Safety Recall Circular

Code: 70D4
Subject: 2009 Q5
Replace Middle Clip of A-pillar Cover
December 2009
Claim Entry Procedure

Tip: Illustration shows left side of vehicle; right side is symmetrically opposite

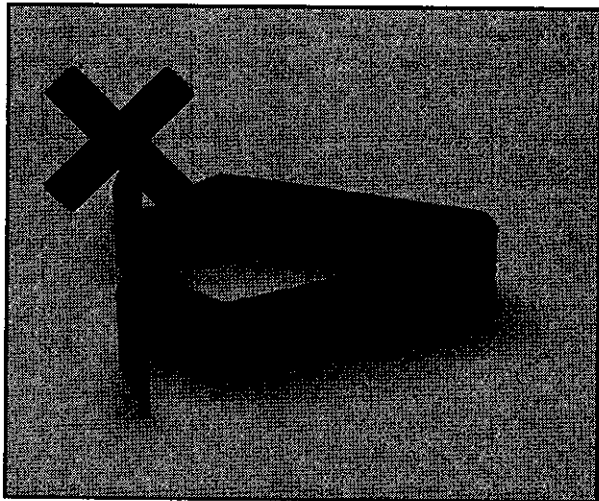
Tip: If outer two trim clamps remain in the body mounting points, remove them and insert them in the trim. If clamps are damaged or deformed, they must be replaced with new parts

Tip: If center trim clamp -circle- remains in the body mounting, remove and discard trim clamp

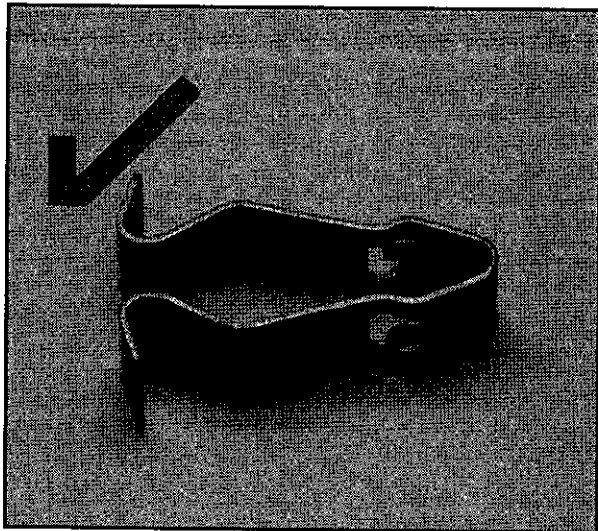
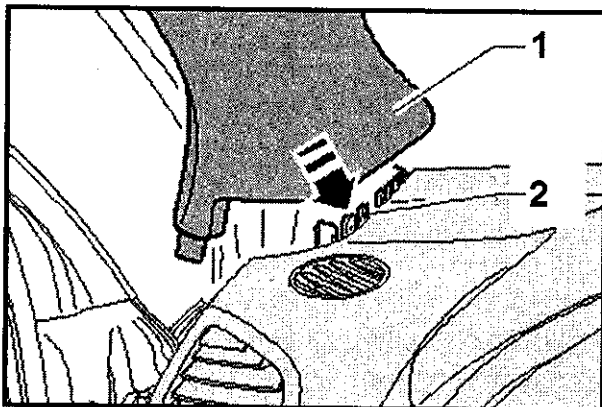
Tip: Old retaining clip (must be removed)

Tip: New retaining clip part number
(8Z0 867 276)

- ⇐ Remove center retaining clip -circle- and install new retaining clip part number (8Z0 867 276)
